HISTORIC AND DESIGN REVIEW COMMISSION

January 15, 2025

HDRC CASE NO: 2024-420
ADDRESS: 301 BRAHAN BLVD
LEGAL DESCRIPTION: NCB 3855 BLK 1 LOT 18
ZONING: RM-4 CD, H
CITY COUNCIL DIST.: 2
DISTRICT: Westfort Historic District
APPLICANT: Ben Bowman/Assets and Architects
OWNER: Laura Miller/MILLER LAURA DELAINE
TYPE OF WORK: Exterior Alterations, Fenestration Modifications, Repair and Maintenance
APPLICATION RECEIVED: December 18, 2024
60-DAY REVIEW: February 16, 2025
CASE MANAGER: Caitlin Brown-Clancy
REQUEST:

MILLER HOUSE

SHEET TITLE
EXISTING
EXTERIOR ELEVATIONS

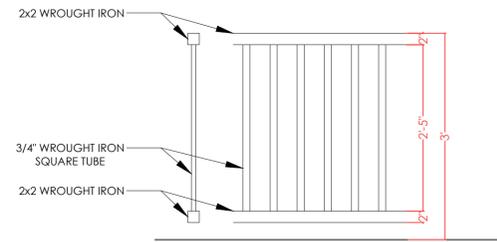
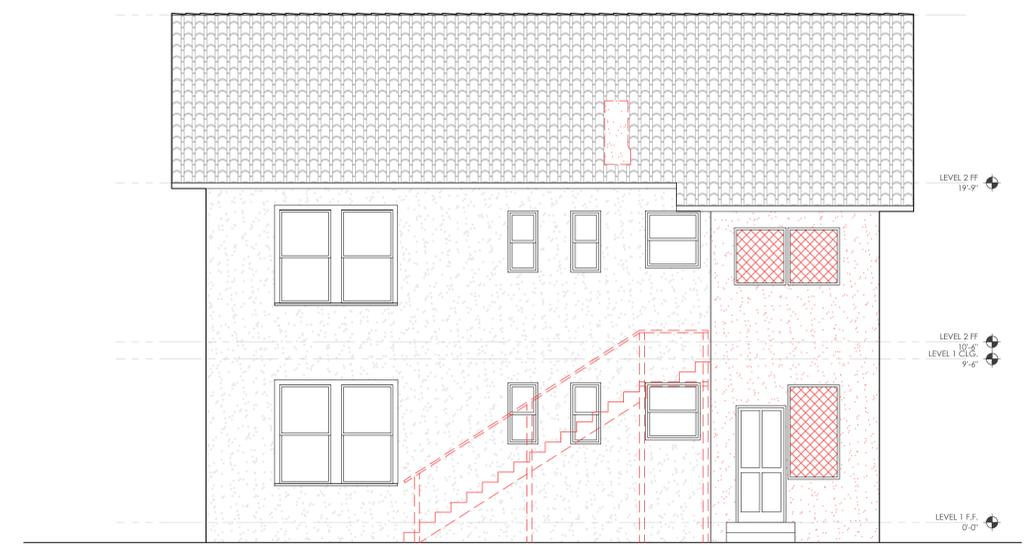
- c. **REAR PORCH/PATIO** – The applicant is requesting to open the existing enclosed double height service porch at the NW corner of the primary structure and replace with a covered rear entry porch and open balcony at the second floor and the addition of a raised rear patio spanning the structure’s width and featuring Saltillo tile. Guideline 7.b.ii states that alterations to side and rear porches should result in a space that functions, and is visually interpreted as, a porch. Staff finds the request appropriate.

- d. **FENESTRATION MODIFICATIONS/PATTERN** – The applicant has proposed to modify the fenestration on the rear façade by removing six (6) historic windows and modifying the existing historic fenestration pattern. The applicant has proposed to replace four (4) of the windows with a fully wood window product and two (2) ganged windows with fully wood French doors. Guideline 6.a.i. states that existing window and door openings should be preserved and that the creation of new primary entrances or window openings on the primary façade should be avoided. Staff finds the proposed modifications appropriate as the request does not reduce the amount of fenestration nor are the modifications posited for the primary façade.

PATIO DETAILS

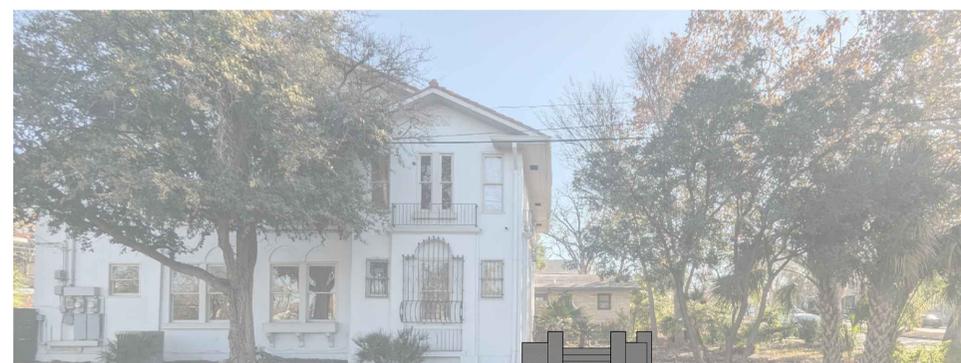
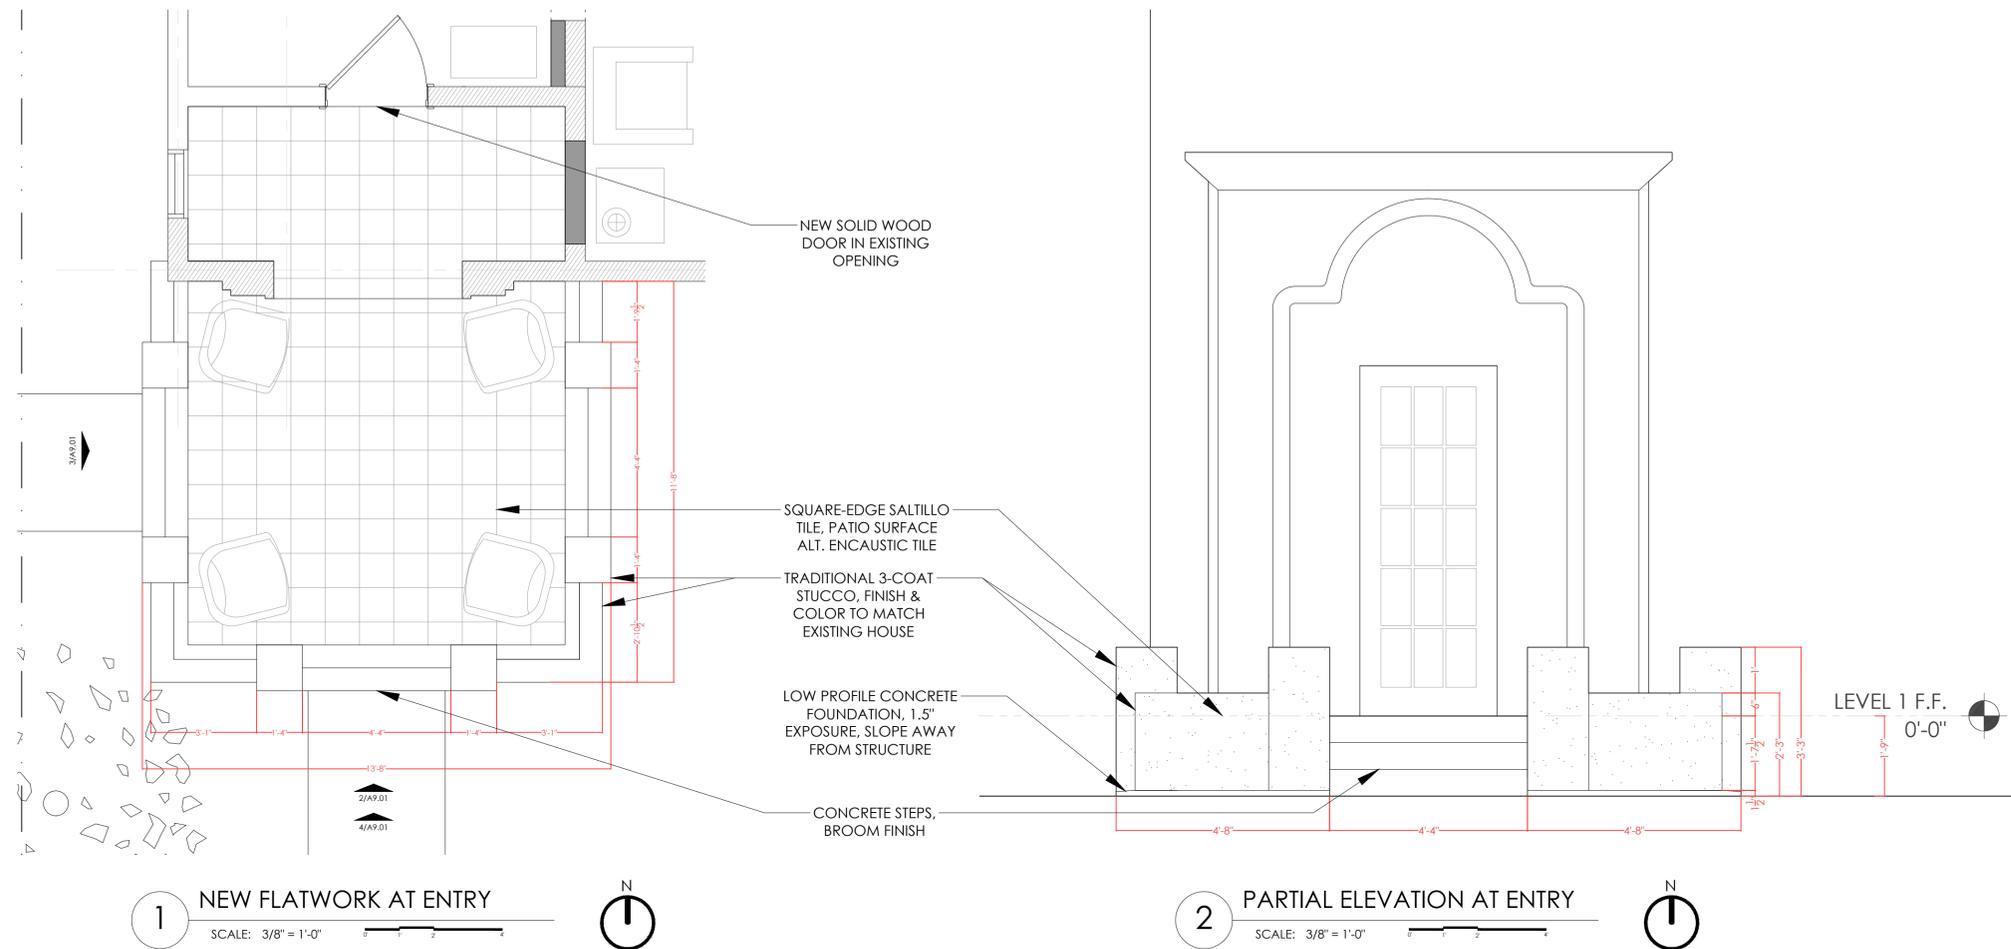
- b. **ENTRANCE** - The applicant has requested to remove the existing flatwork leading up to the front door and replace with a raised patio accessed by stairs on three sides featuring stucco and Saltillo tile. The Guidelines for Exterior Maintenance and Alterations 6.b.ii. states that new entrances should be compatible in size, scale, shape, proportion, material, and massing with historic entrances. Staff finds the design appropriate based on the architectural style and scale of the primary structure. The applicant has also requested to replace the existing front door with a new solid wood door; however, the applicant has not submitted any product specification for the front door. Staff finds the applicant should submit product specifications for review prior to final approval.

- e. **MATERIALS** – The applicant has proposed the use of stucco and Saltillo tile for both the front and rear patios. The Guidelines for New Construction state that new materials should complement the type, color, and texture of materials traditionally found in the district. Materials should not be so dissimilar as to distract from the historic interpretation of the district. Staff finds the proposed materials appropriate and consistent with the guidelines.

- f. **ARCHITECTURAL DETAILS** – The applicant has proposed details for the front and rear patios that feature a low-profile stucco stair surround. Guideline 4.a.ii. states that architectural details should be in keeping with the predominant architectural style along the block face or within the district when one exists. Details should be simple in design and should complement, but not visually compete with, the character of the adjacent historic structures or other historic structures within the district. Staff finds this design choice consistent with the Guidelines.

- i. That the applicant submit product specifications for the front door replacement and photos of the existing windows and garage doors of the casita.
- ii. That the applicant salvage as much existing material as possible, including structural members, windows, and doors for reuse on site, resale, or donation.
